CWSP SYSTEM HARDENING FIELD SCOPING DOCUMENT

PM: 35192284	Project Name: ECOP - SILVERADO 2104 - H05-LR726	
Notification: 119556691	Region: Bay Area	City: Pope Valley
Project Manager: [REDACTED]	Division: North Bay	County: Napa

Fire History:

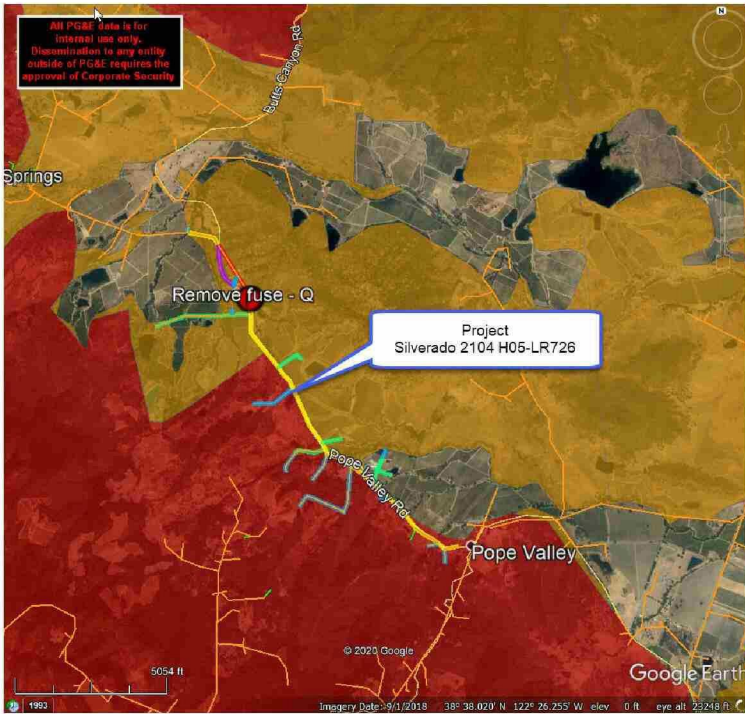
- This area has significant fire history directly impacting the project area. These fires include the Glass and LNU Complex of 2020, Kincade Fire of 2019, County Fire 2018, Atlas, Tubbs and Nuns Fires of 2017, Rocky, Valley, and Jerusalem of 2015.

Fire History:

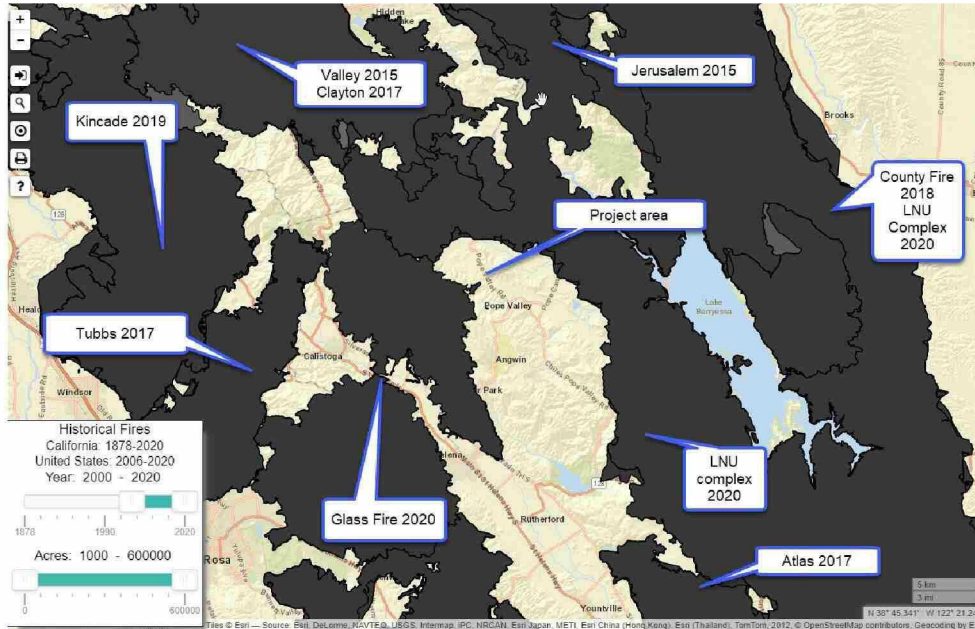
- Area of un-tiered area should remain hardened as recommended due to location of Tier 2 and Tier 3 around it.
